Figure 0-5—Block lock state diagram

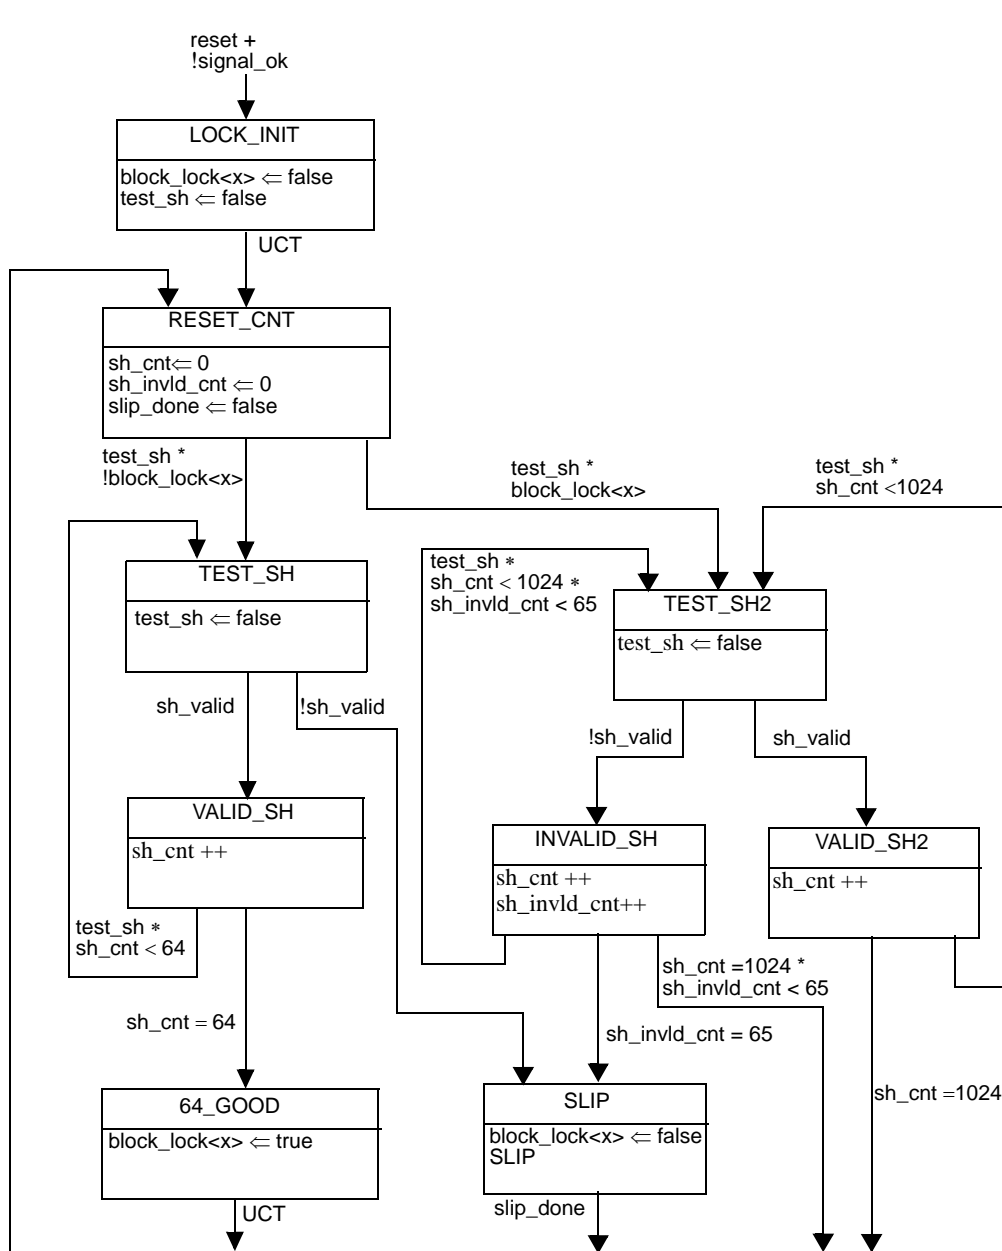
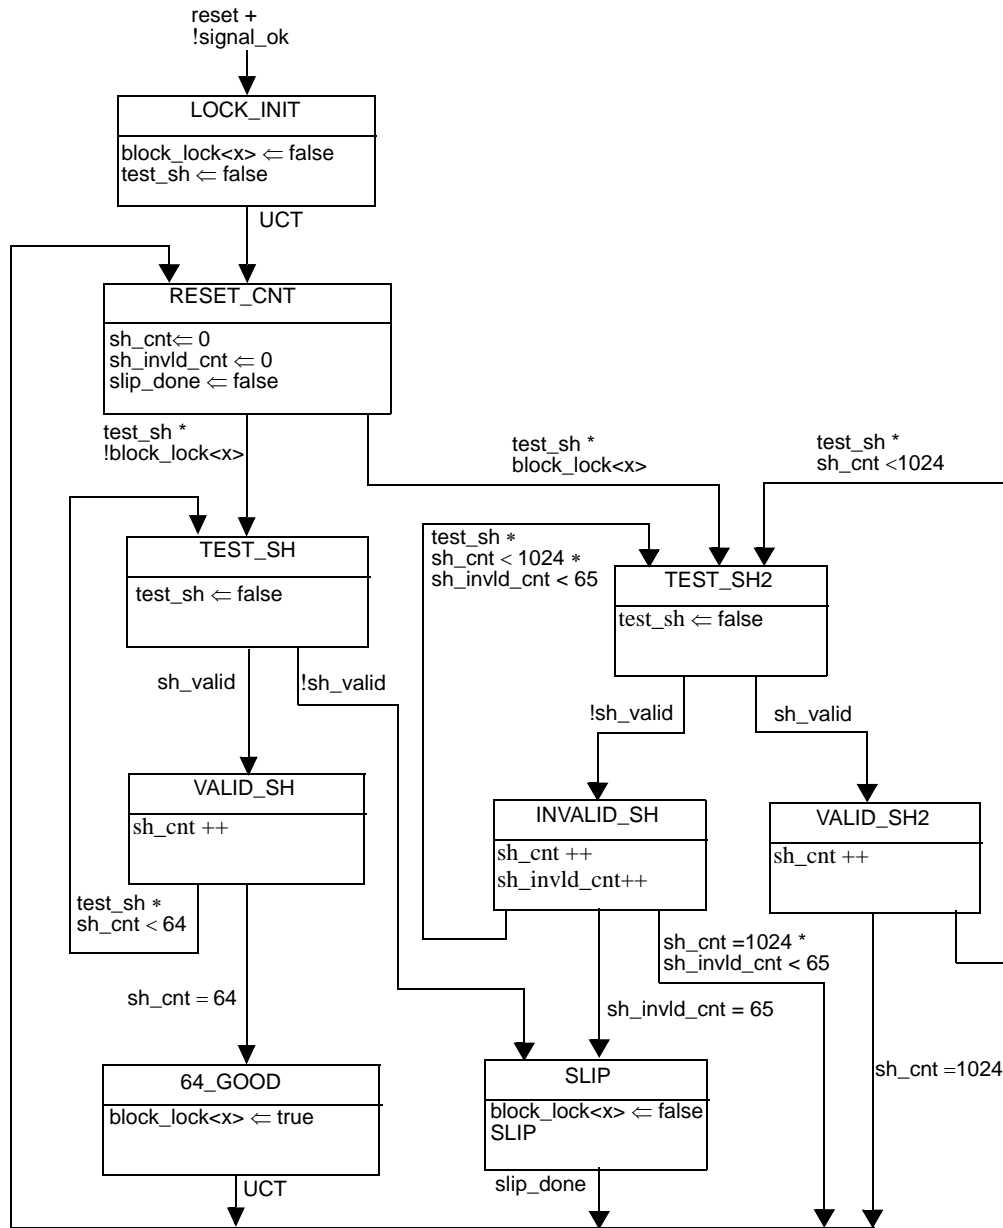
The 40GBASE-R PCS shall implement four ~~PCS-lane-block~~ lock processes as depicted in Figure 0–3. The 100GBASE-R PCS shall implement twenty ~~PCS-lane-block~~ lock processes as depicted in Figure 0–3. A ~~PCS-lane-block~~ lock process operates independently on each ~~PCS-lane~~. Each ~~PCS-lane-block~~ lock process looks for 64 valid 66b sync fields in a row to declare lock. A valid sync field is either a 01 or a 10. Once in lock, the lock process looks for 65 invalid sync fields within a 1024 sync window to declare out of lock. An invalid sync field is a 11 or 00. Once ~~PCS-lane-block~~ lock is achieved on a ~~PCS-lane~~, then the ~~PCS~~-alignment marker process starts.

Note - block\_lock<x> refers to the received PCS lane x, where x = 0:3 (for 40GBASE-R) or 0:19 (for 100GBASE-R)

Note - block\_lock<x> refers to the received lane x of the service interface, where x = 0:3 (for 40GBASE-R) or 0:19 (for 100GBASE-R)

Figure 0-6— Alignment marker lock state diagram

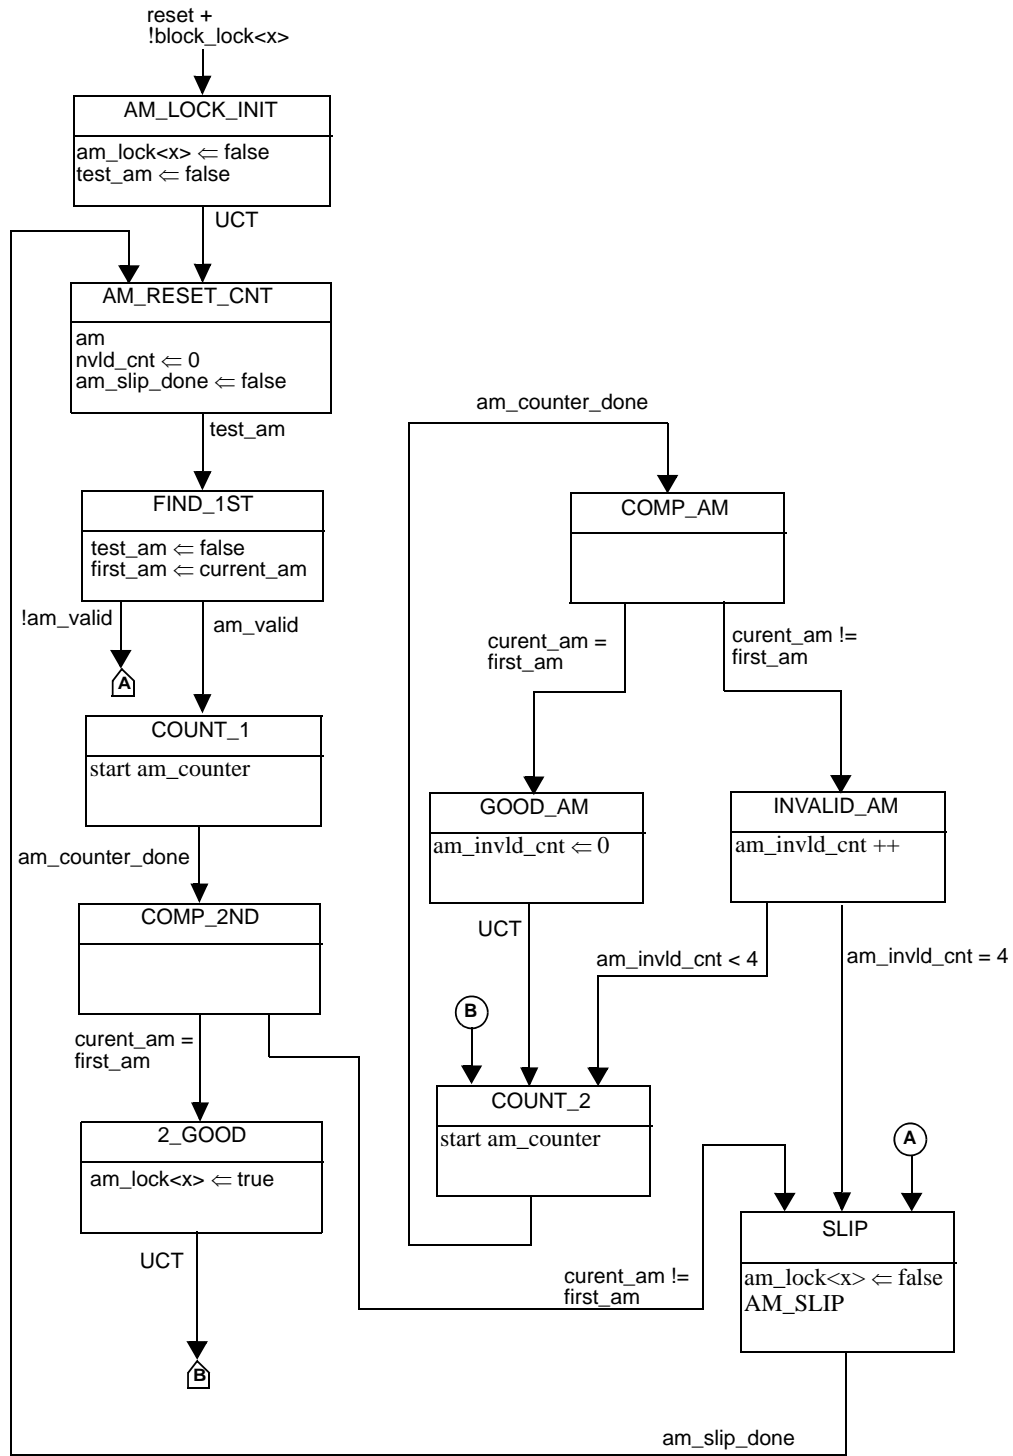
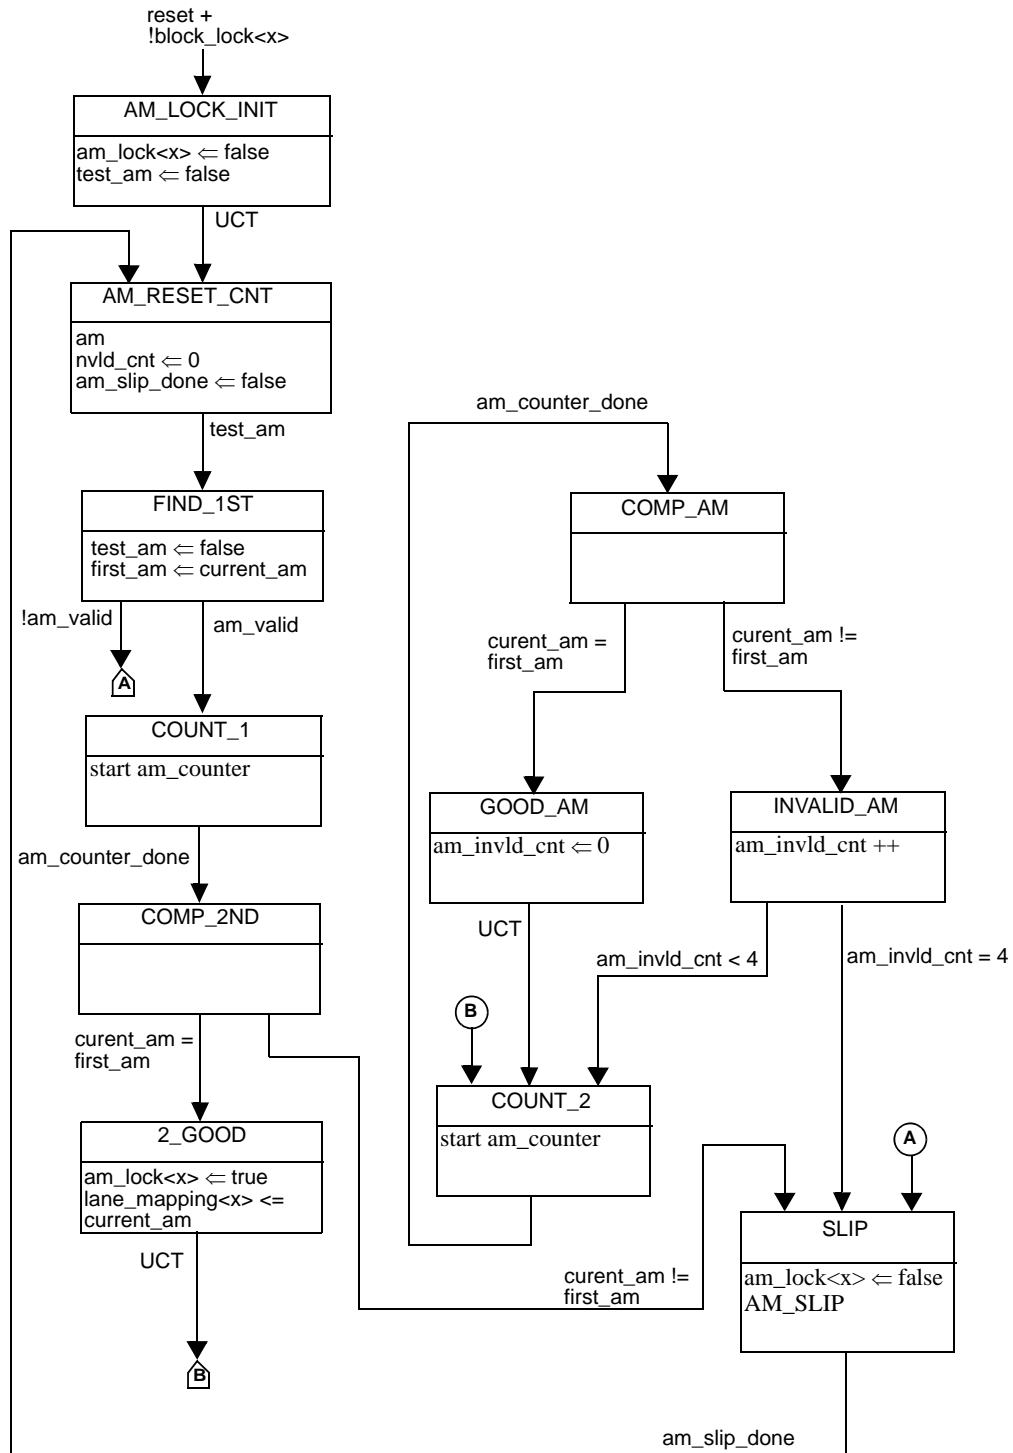
The 40GBASE-R PCS shall implement four ~~PCS~~-alignment marker lock processes as depicted in Figure 0–4. The 100GBASE-R PCS shall implement twenty ~~PCS~~-alignment marker lock processes as depicted in Figure 0–4. A ~~PCS-An~~ alignment marker lock process operates independently on each ~~PCS-lane~~. The ~~PCS~~ alignment marker lock state diagram shown in Figure 0–4 determines when the PCS has obtained alignment marker lock to the received data stream for a given ~~PCS-lane~~ of the ~~service interface~~. Each alignment marker lock process looks for two valid alignment markers 16384 66b blocks apart to gain alignment marker lock. On a given ~~PCS-lane~~ of the ~~service interface lane~~ markers must match each other and an entry from Table 82–2 for 100GBASE-R or Table 82–3 for 40GBASE-R. Note that the BIP<sub>3</sub> and BIP<sub>7</sub> fields are excluded from the markers when making a match to each other or the tables. Once in lock, a ~~PCS-lane~~ will go out of alignment marker lock if four markers are received in a row that do not match the alignment marker that the ~~PCS-lane~~ is currently locked to.

Note - am\_lock<x> refers to the received lane x, where x = 0:3 (for 40GBASE-R) or 0:19 (for 100GBASE-R)

Note - am\_lock<x> refers to the received lane x of the service interface, where x = 0:3 (for 40GBASE-R) or 0:19 (for 100GBASE-R)
